SUBJECT: NEW ORCHARD FARM ELEMENTARY SCHOOL  
ORCHARD FARM R-V SCHOOL DISTRICT  
ST. CHARLES, MISSOURI  
PROJECT # 23-09B

Enclosed please find one (1) electronic .pdf copy of Addendum No. 2, dated August 1, 2024, for the above-named project.

ORCHARD FARM R-V SCHOOL DISTRICT  
NEW ELEMENTARY SCHOOL  
ST. CHARLES, MISSOURI

**P2.3**  
SD: 66

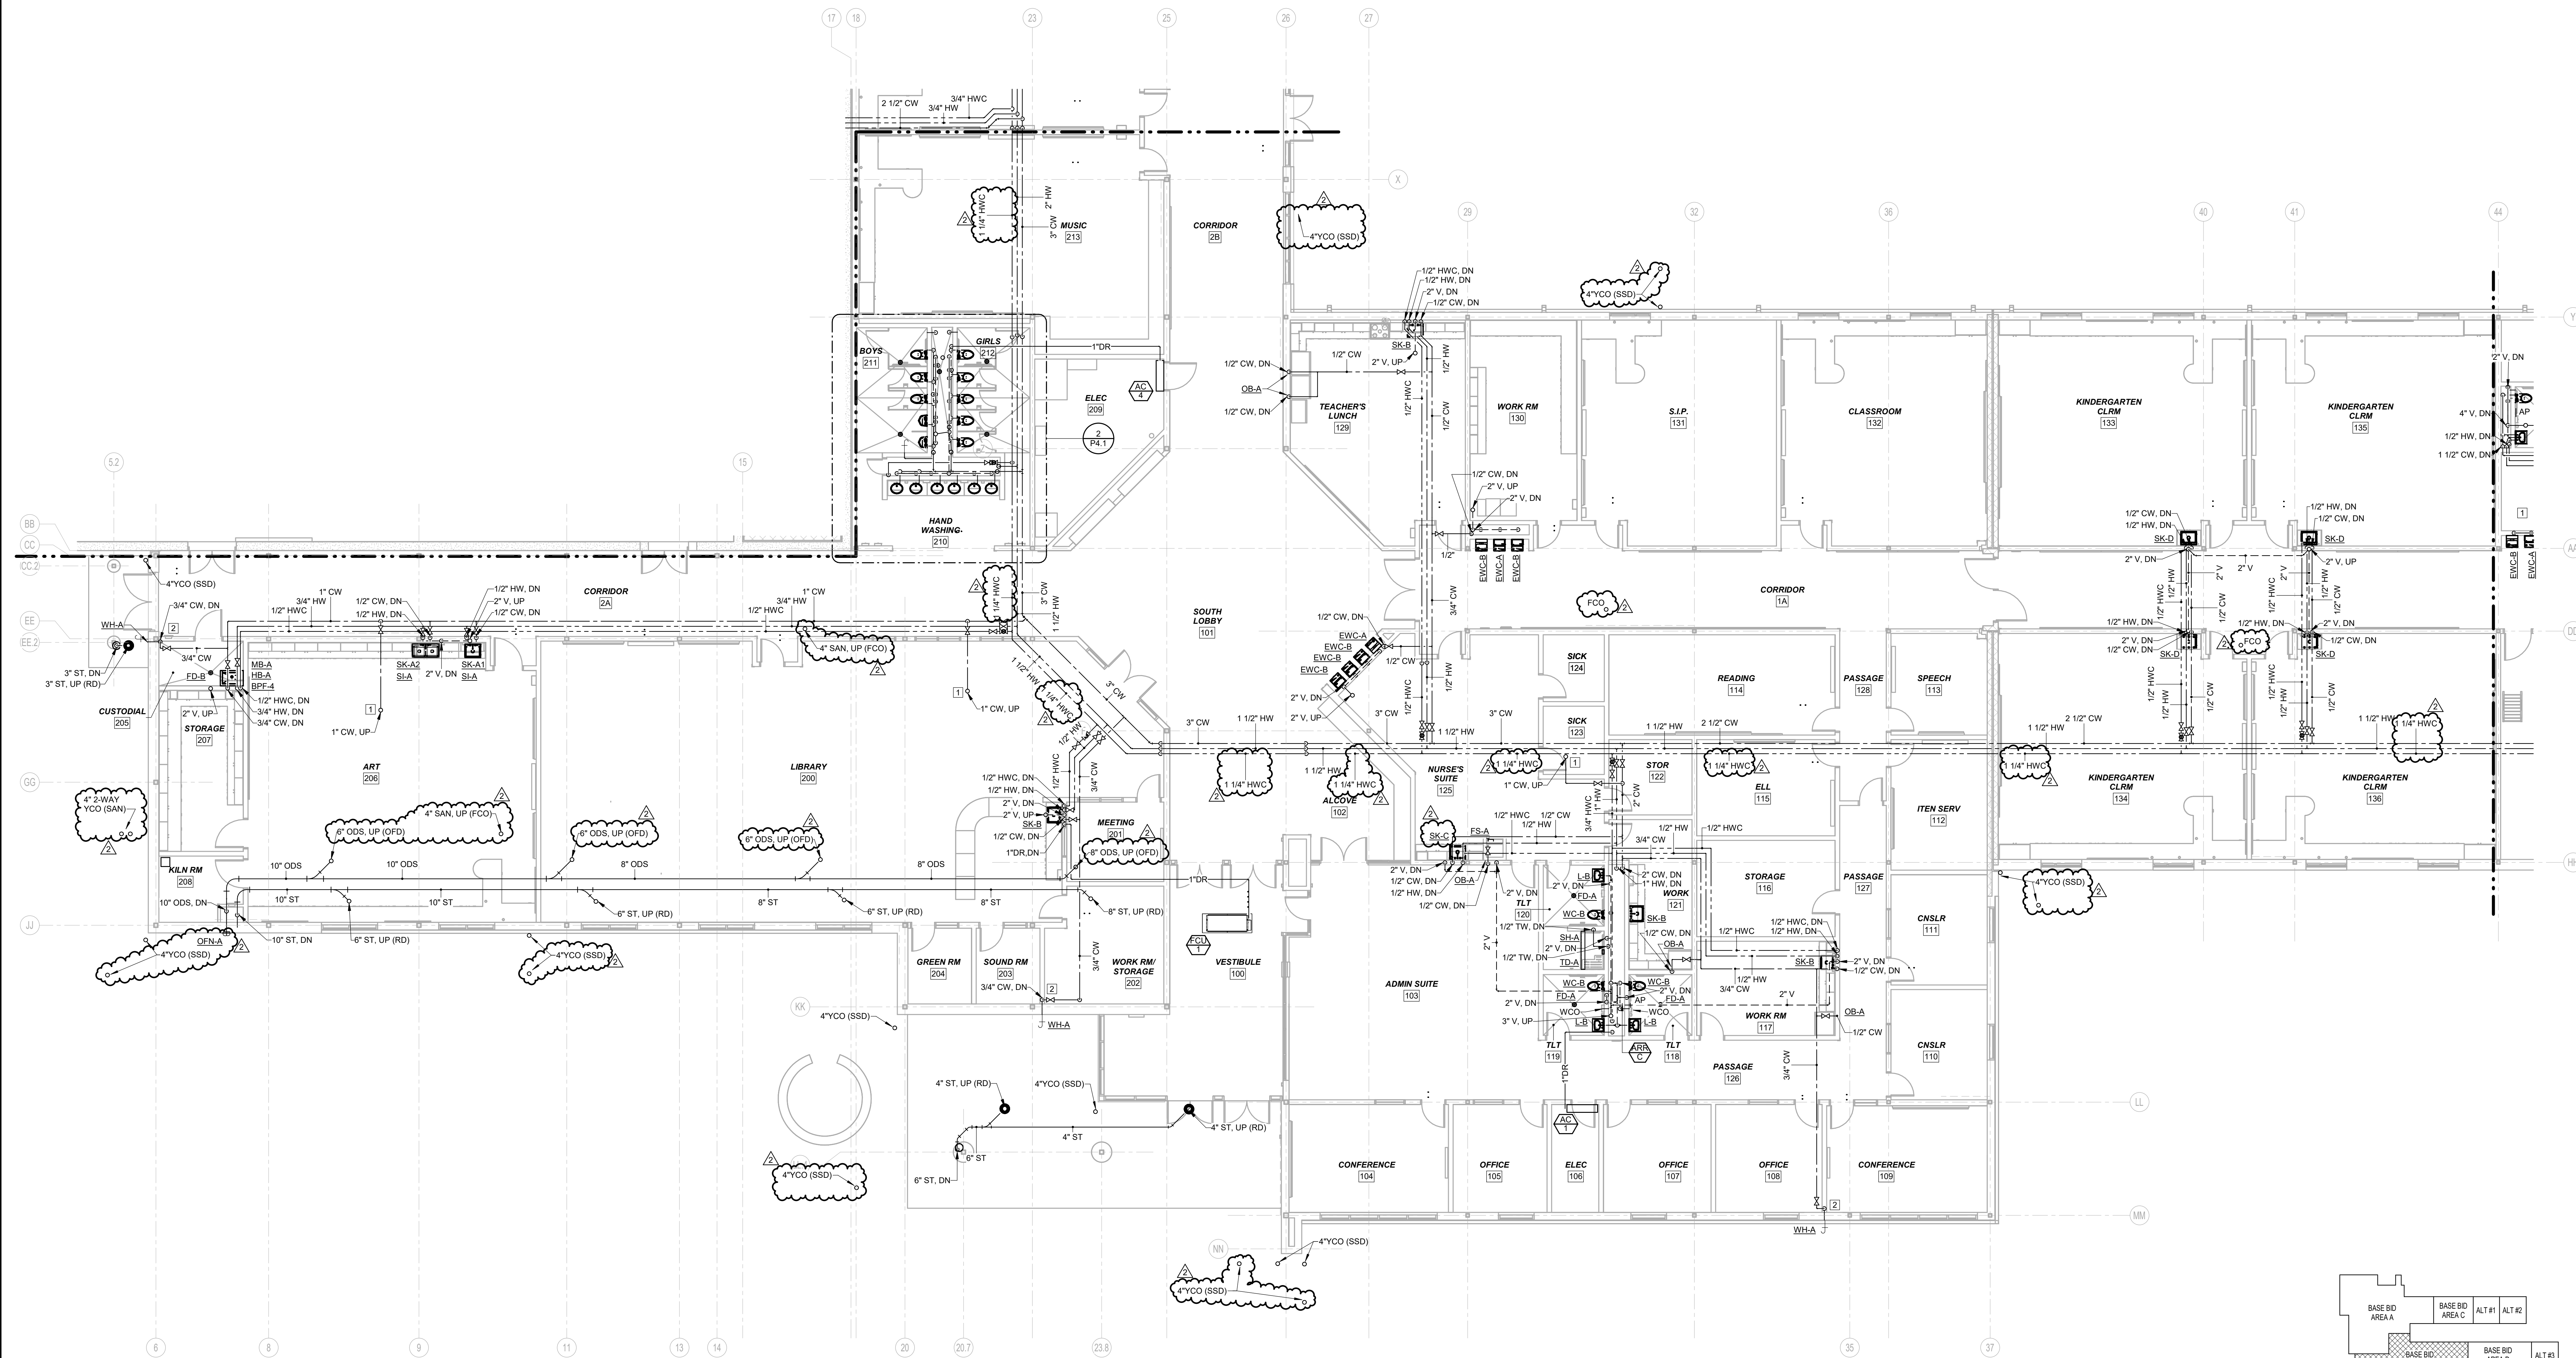
**Answer:** Yes, it should be FD-B. It has been adjusted on plans. See Sheet P2.2.
7. **Question:** Sheet P2.3 – Kiln Rm #208 – ODN-A not specified, possibly mislabeled, is this OFN-A?

8. **Question:** Sheet P2.3 – Nurses Suite #125 – EW-A not scheduled or specified, please clarify.  
**Answer:** There shall be no EW-A in the Nurse’s Suite or anywhere else in the building. It has been removed from the floor plans. See Sheet P2.3.

ITEM NO. 49 – MECHANICAL DRAWING SHEET P2.3

- A. **“REVISE”** Overflow drain designations to match specifications.
- B. **“REVISE”** Domestic hot water return pipe sizes.
- C. **“ADD”** Floor cleanouts.
- D. **“ADD”** Yard cleanouts for secondary subsoil drainage.

**Answer:** Yes, it should be OFN-A. It has been adjusted on plans. See Sheet P2.3.

P2.5  
SD: 68

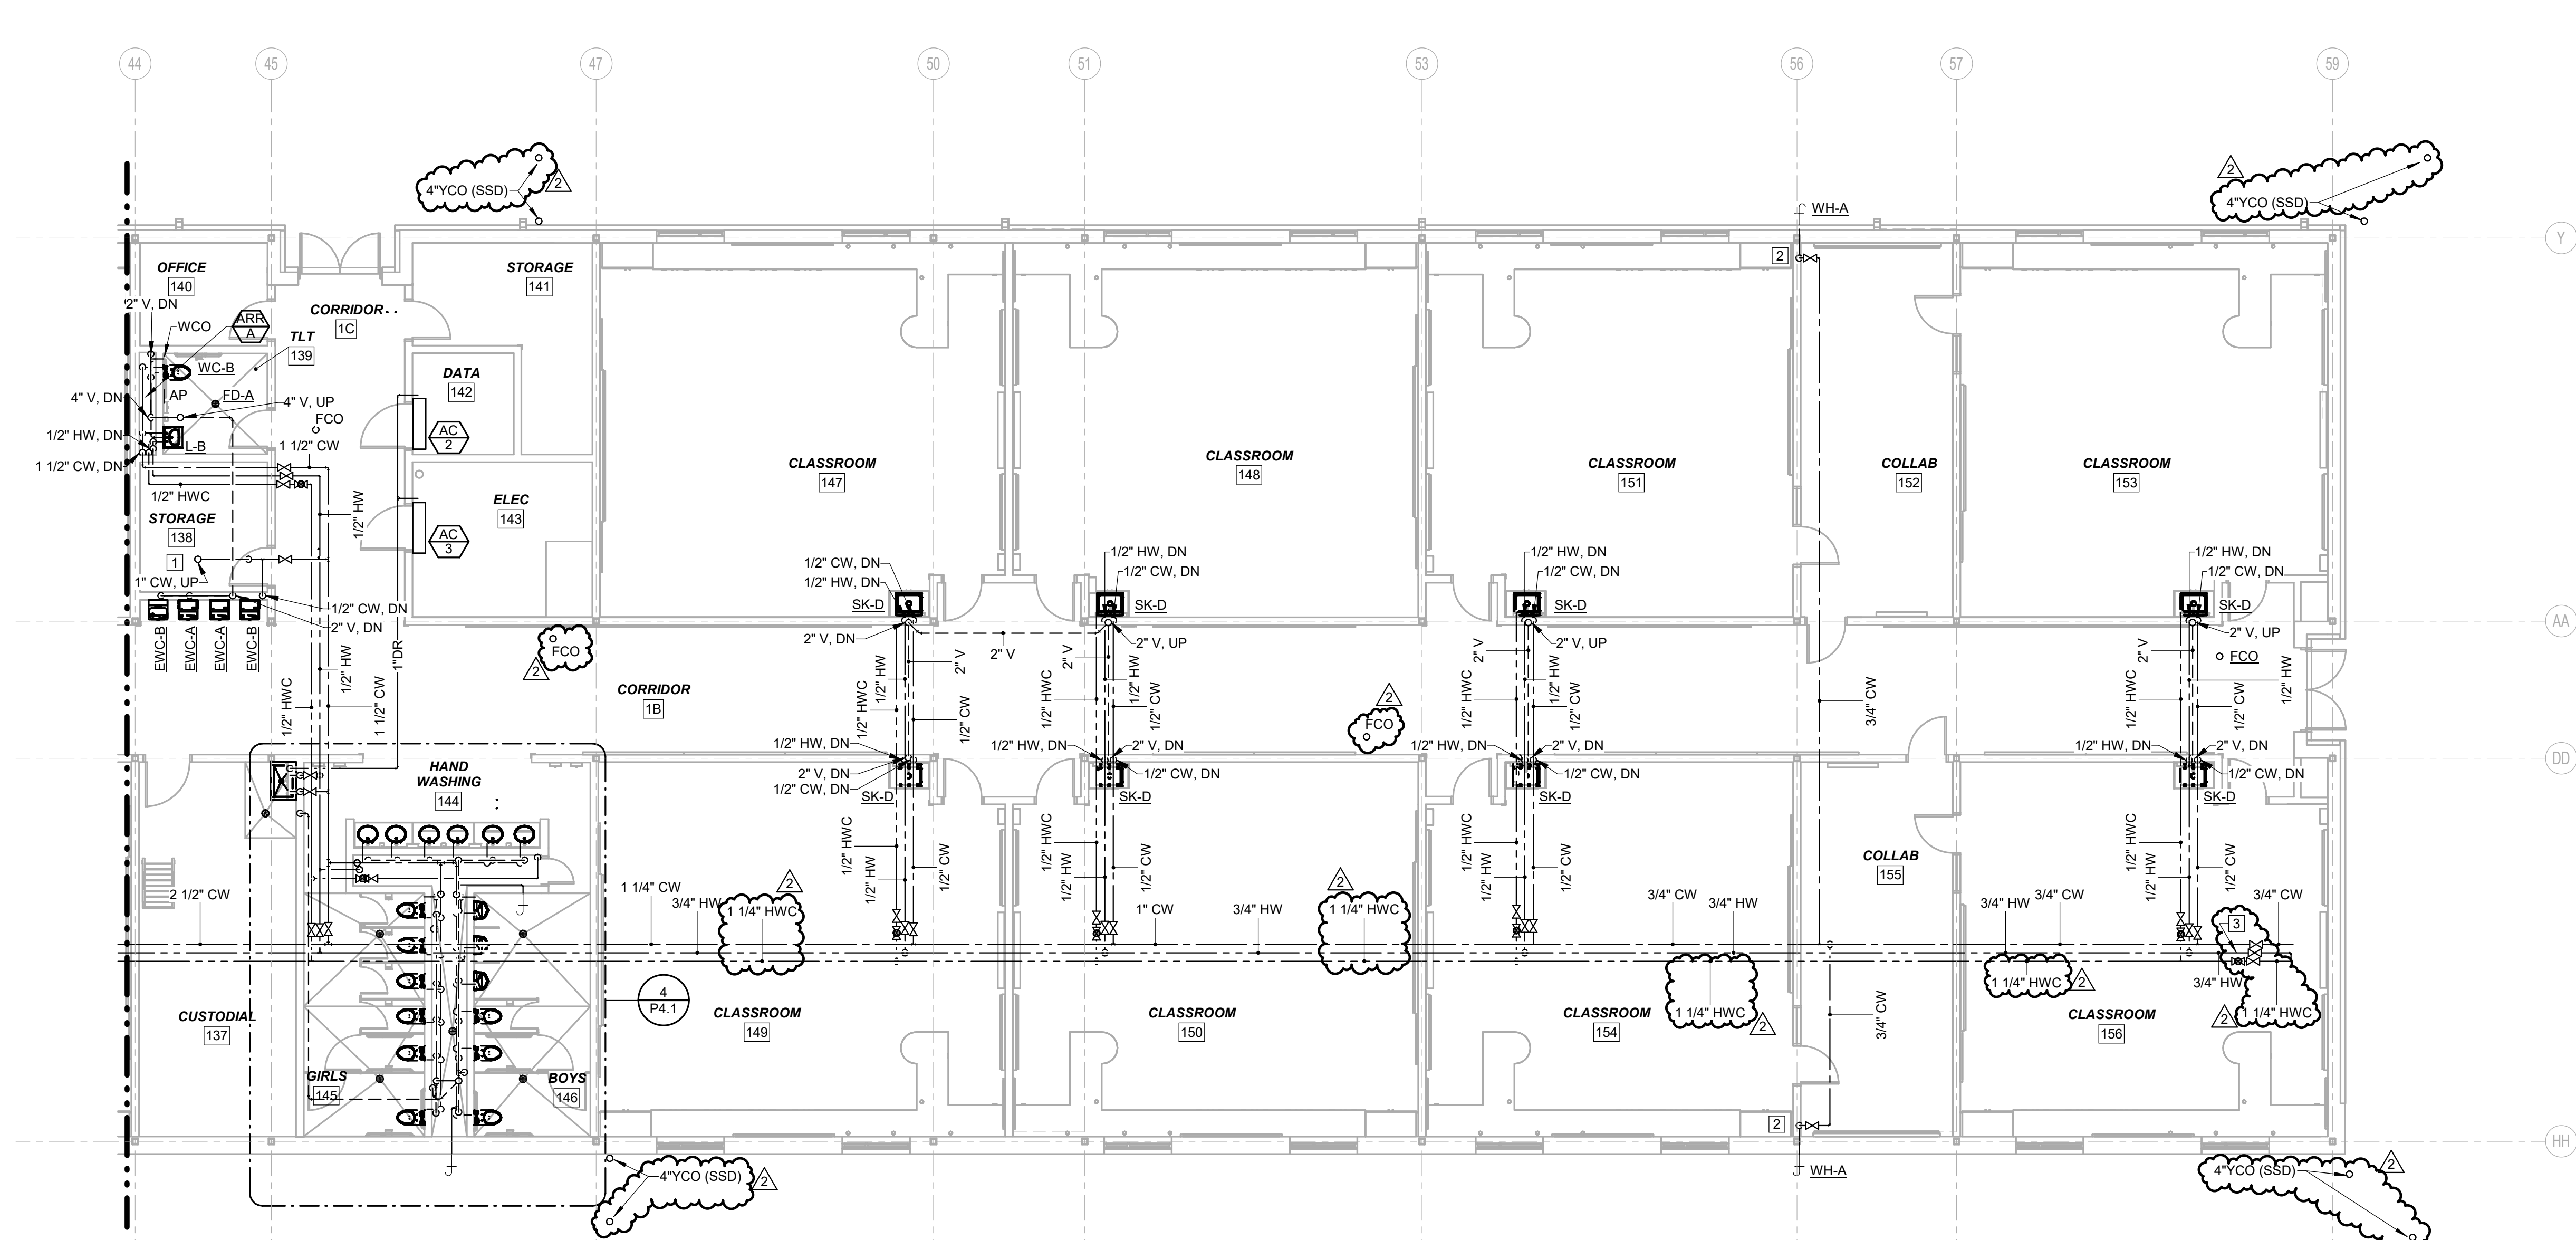
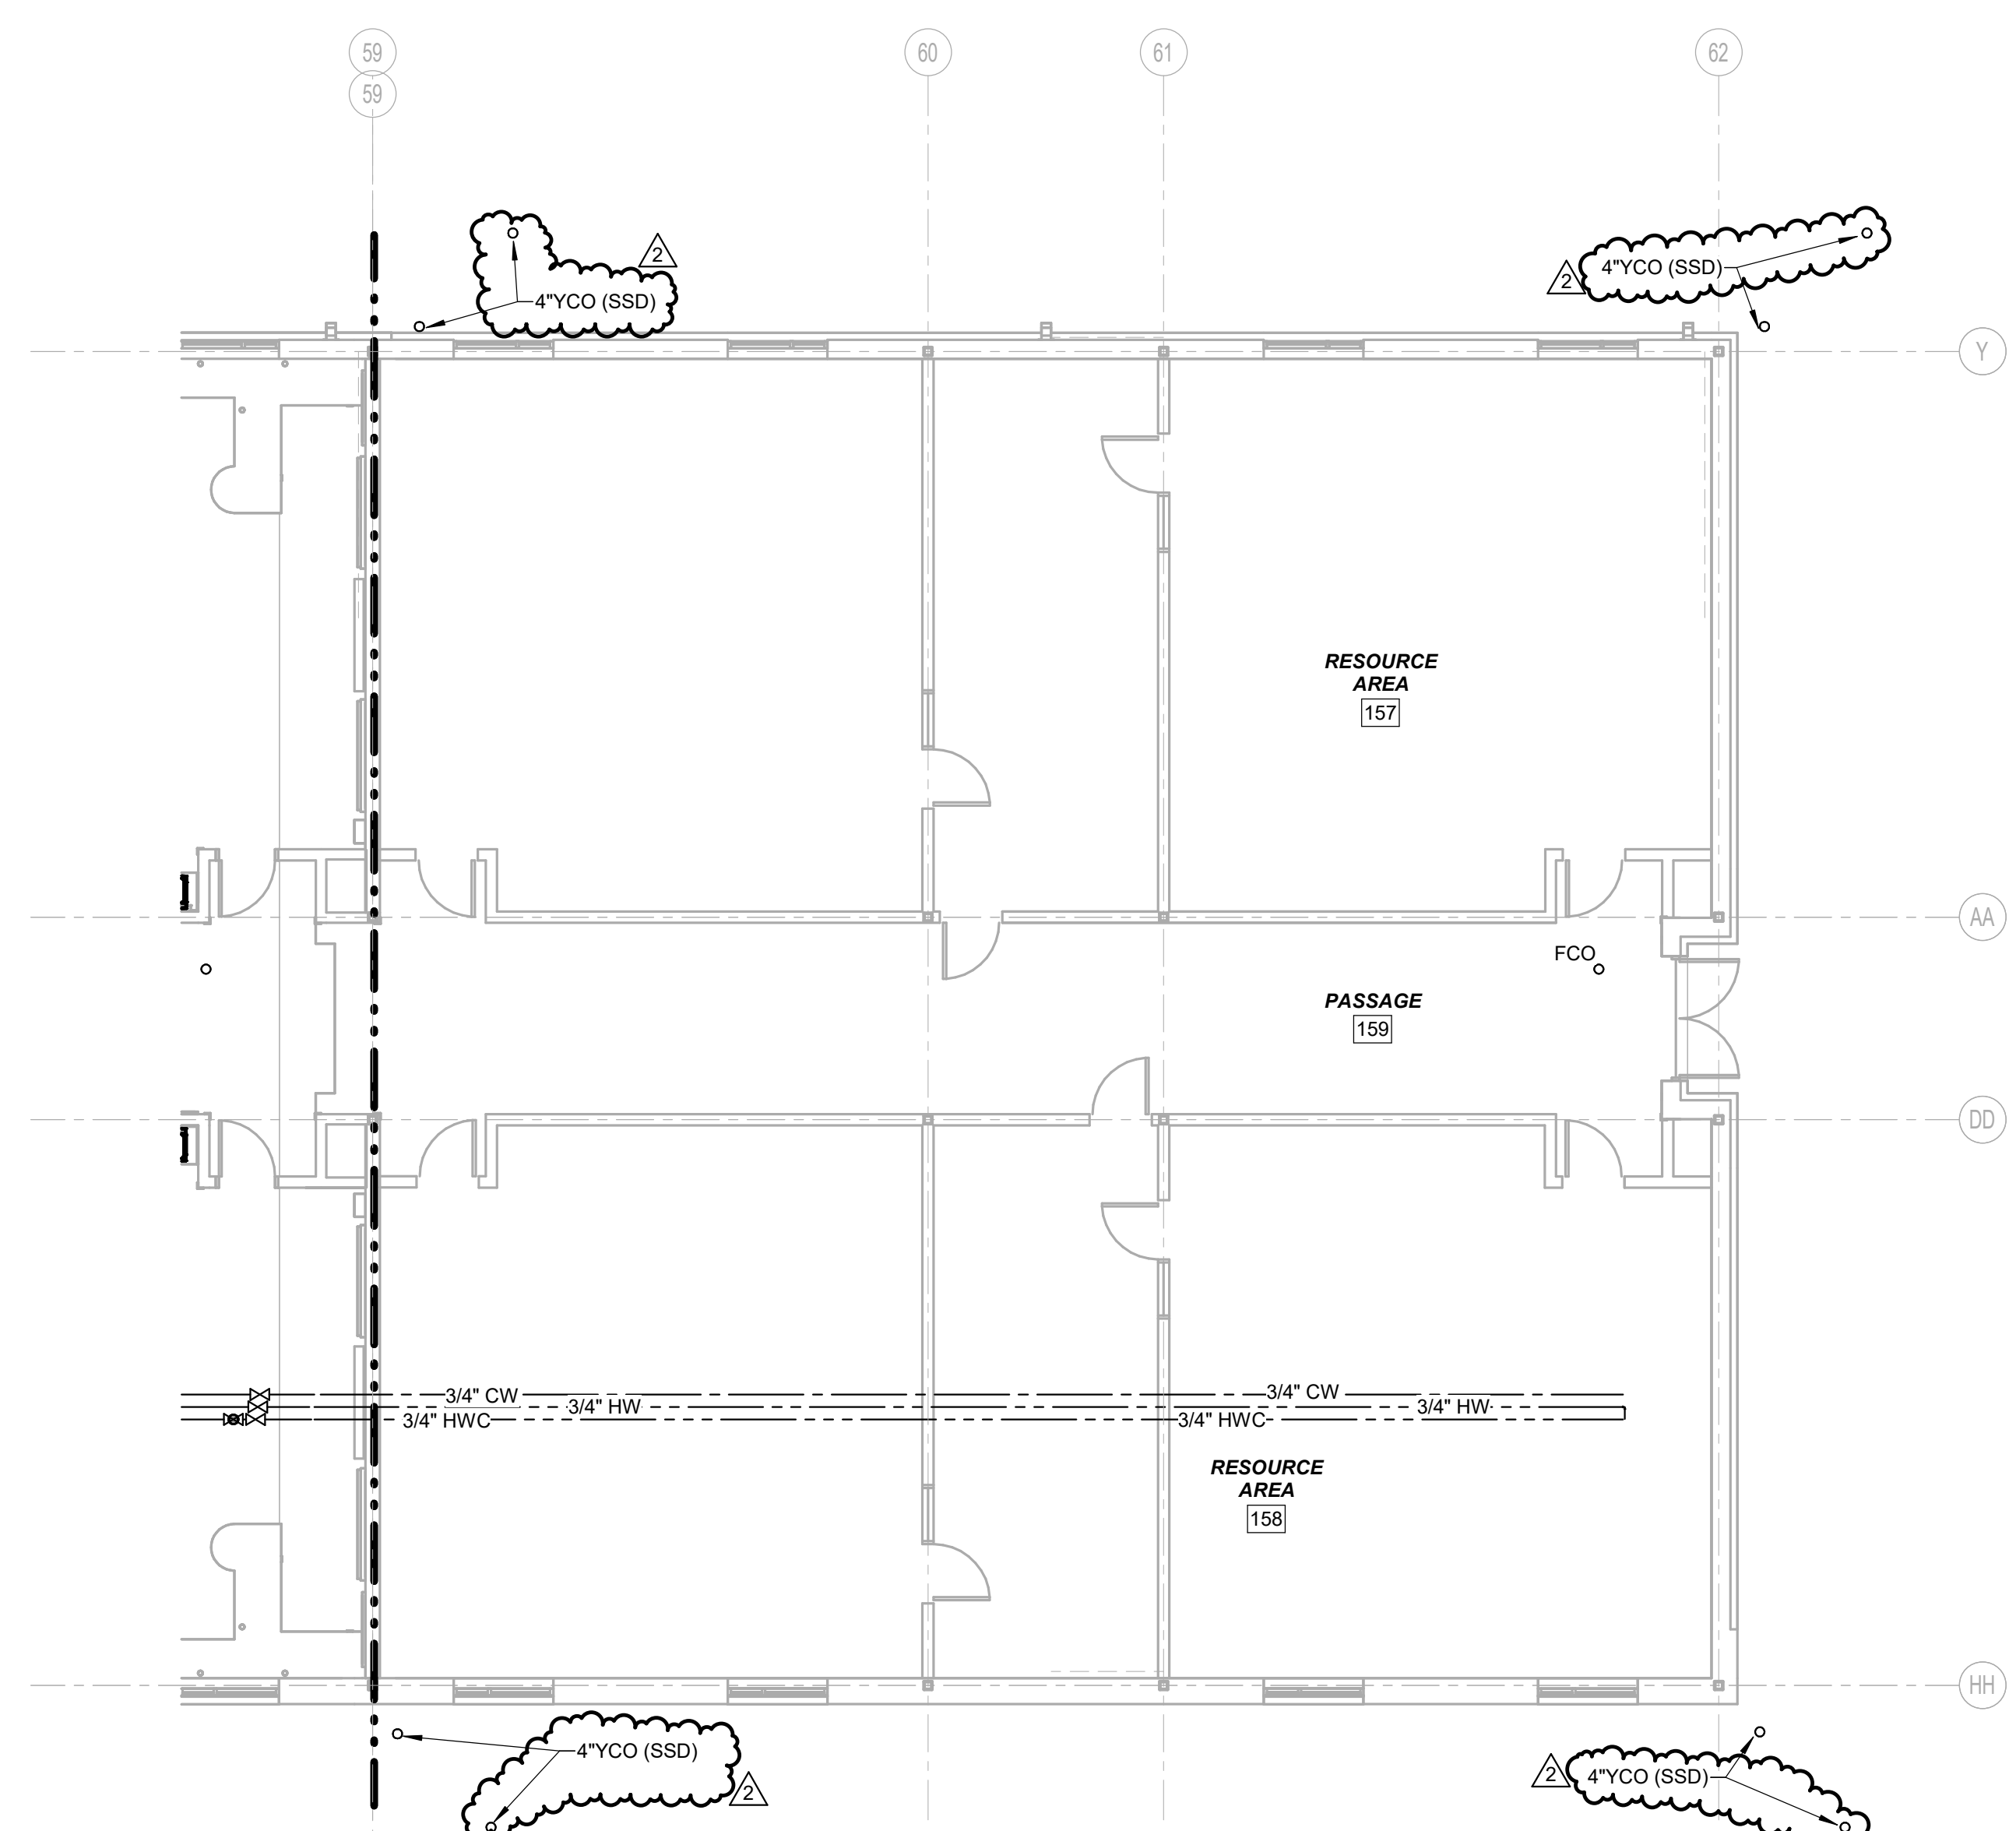
10. **Question:** Sheet P2.4 – Office #423 – Wall hydrant not tagged.  
**Answer:** Tag added. See Sheet P2.4.
11. **Question:** Sheet P2.5 – Classrooms #147, 148, 149, 150, 151, 153, 154, & 156 – SK-D spec’d as oval drawings show rectangular sink, please clarify.

ITEM NO. 51 – MECHANICAL DRAWING SHEET P2.5

- A. **“REVISE”** Domestic hot water return pipe sizes.
- B. **“ADD”** Floor cleanouts.

**Answer:** SK-D has been adjusted in specifications and in plumbing fixture schedule. The sink shall be rectangular.
12. **Question:** Sheet P4.1 – Main Mechanical #305 – ES-A scheduled but not specified, please clarify.
